1.3.1 This report therefore provides a Designers' Response to a new Stage 1 Road Safety Audit (RSA) commissioned to consider the latest access proposals associated with both the Gladman and the MH schemes taking access from Leicester Road, hereon referred to as the 'cumulative access arrangement'.

LEICESTER ROAD, EARL SHILTON PROPOSED ACCESS STRATEGY

STAGE 1 ROAD SAFETY AUDIT

PROPOSED ACCESS DRAWING P21008-100-2C

9.1 Leicester Road – General view looking north from proposed access

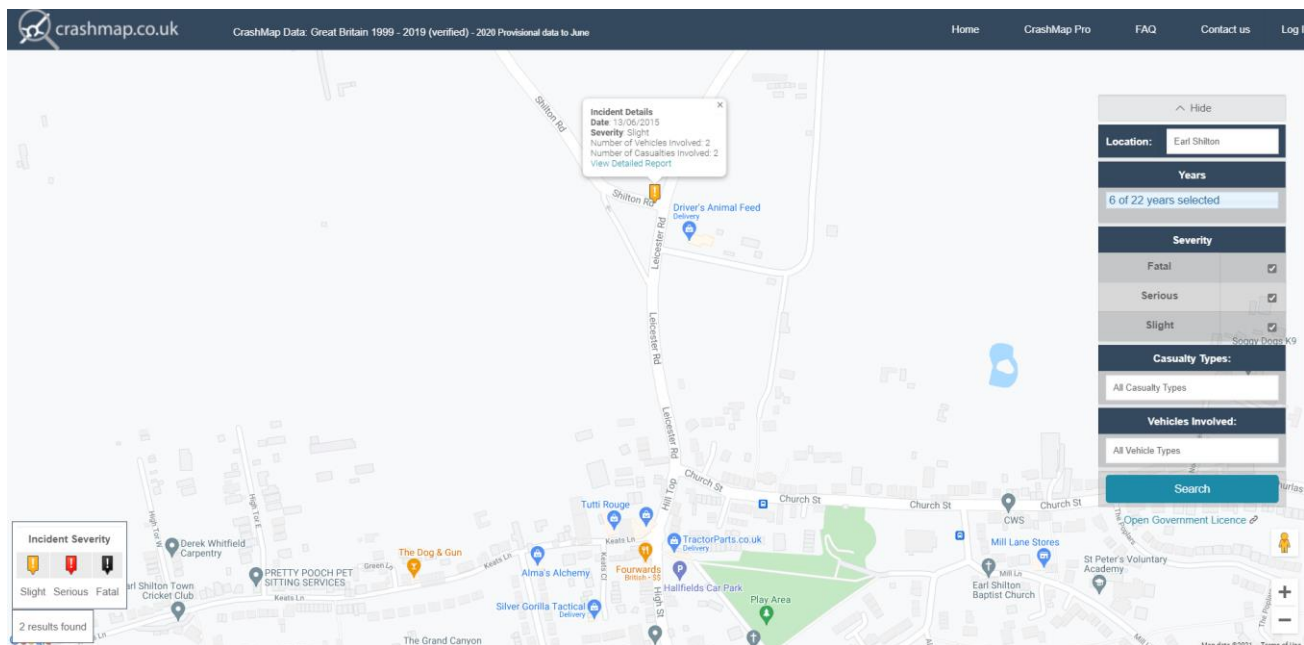
It was observed on site that the proposed junction is located outside the limits of the existing street lighting system on Leicester Road. A lack of street lighting at the proposed junction where increased vehicle turning manoeuvres will occur may increase the risk of vehicular and vehicular/pedestrian or cyclist collisions during the hours of darkness. (Photo 10.2)

- 3.2.1 An appropriate street lighting design incorporating the proposed junction arrangement will be provided at the reserved matters stage.

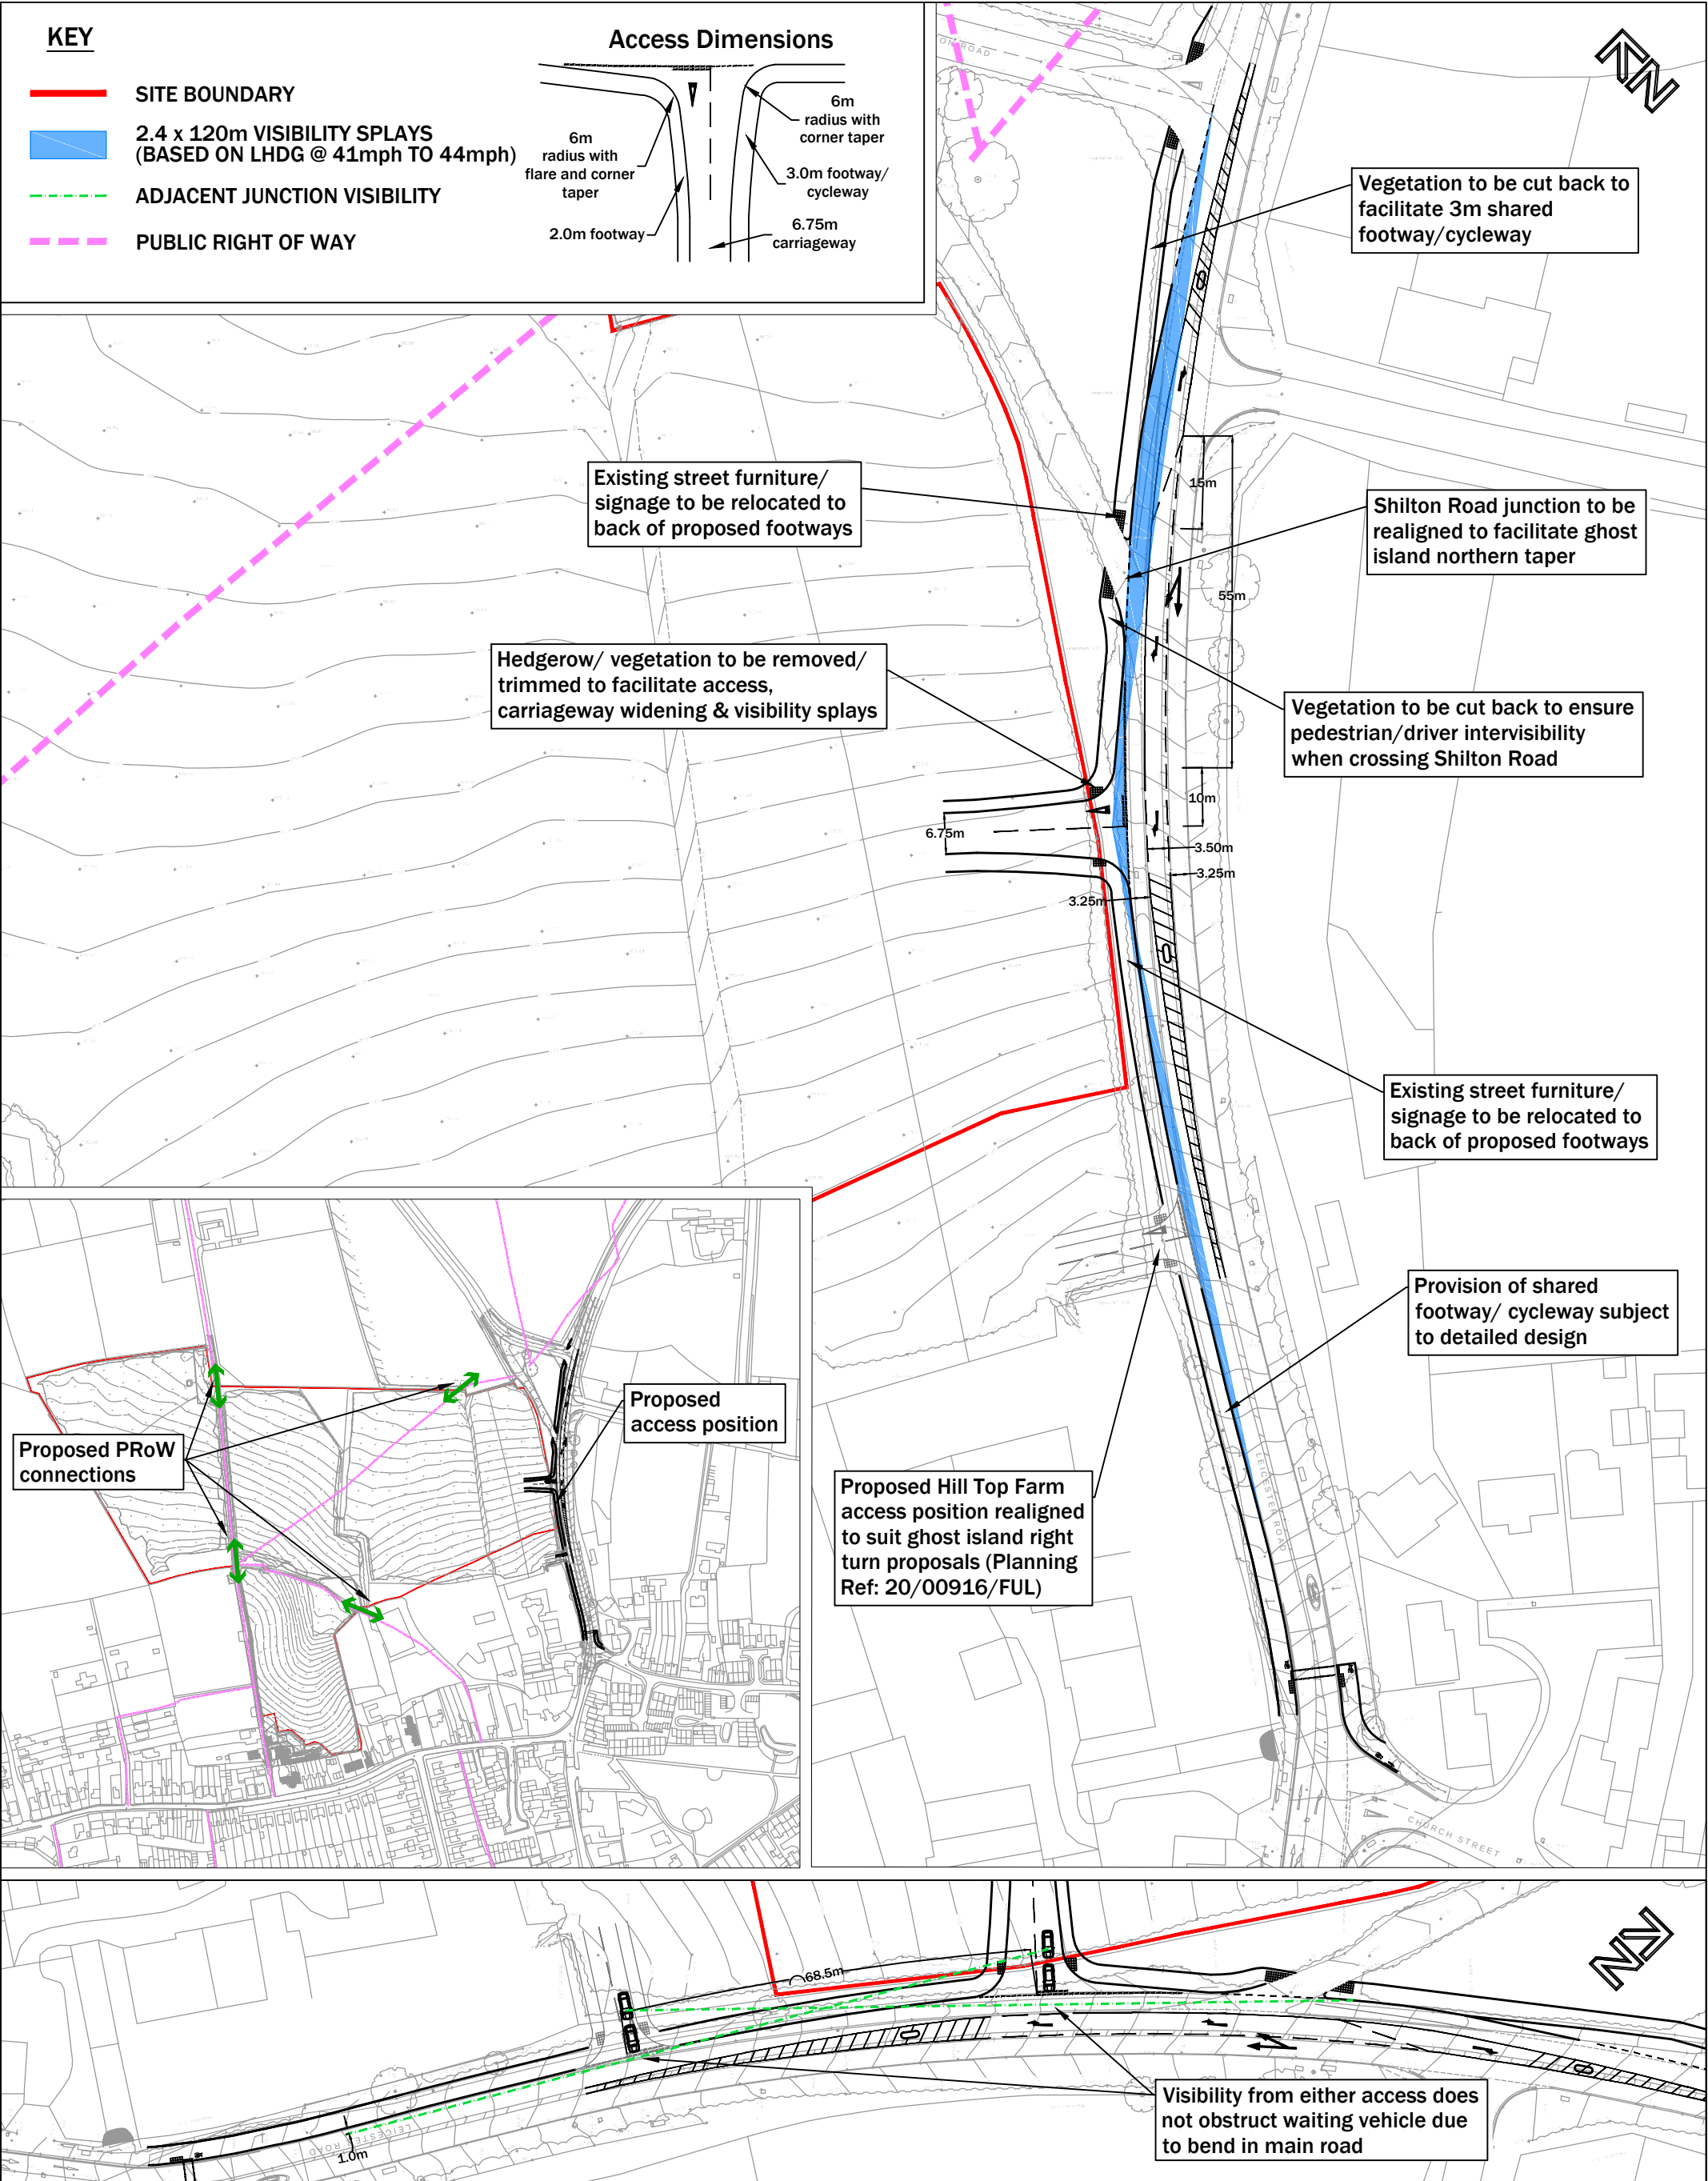
There is an existing gully located in close proximity to the proposed uncontrolled pedestrian crossing on the western side of Leicester Road which may be within the limits of the uncontrolled pedestrian crossing. The location of the gully may result in a trip hazard for pedestrians who may get their shoe caught in the gully cover or may create manoeuvrability issues for those with pushchairs/wheelchairs, who may get their wheels caught in the gully cover, increasing the risk of collisions with passing vehicles.

It is recommended that the proposed location of the uncontrolled pedestrian/cyclist crossing is amended if it is found that the existing gully is located within the limits of the crossing.

The intervisibility between pedestrians/cyclists crossing Leicester Road at the proposed uncontrolled crossing and drivers approaching from the north and south may be obscured by the existing traffic signs to the north and the highway vertical alignment to the south. A reduction of intervisibility may increase the risk of collisions between pedestrians/cyclists and approaching vehicles, as those crossing the carriageway may fail to sufficiently appreciate approaching traffic and vice versa.

It is recommended that the intervisibility between pedestrians/cyclists crossing the carriageway and approaching drivers should be investigated and any obstructions found within the intervisibility splays should be removed. Additionally, if it is found the highway vertical alignment obscures visibility then the proposed uncontrolled crossing should be relocated.

- 3.2.7 This is noted and as such the crossing is proposed to be relocated very slightly further north to avoid the gully as well as the BT chamber on the opposite side as shown on Drawing P21008-100-2C in Appendix III.

- 3.2.8 Whilst the location of the crossing is now proposed to be slightly relocated to avoid the gully this does not change the comment. We are however confident that this is a safe and appropriate location for the crossing with a good level of visibility. We believe that this is the optimum location for the crossing with consideration of the Church Street junction. Should the signage be considered to interfere with the visibility, it can be rationalised and fully considered during the detailed design process. If LCC were to allow the extension of the 30mph speed limit, the signage would be relocated further away from the crossing point.
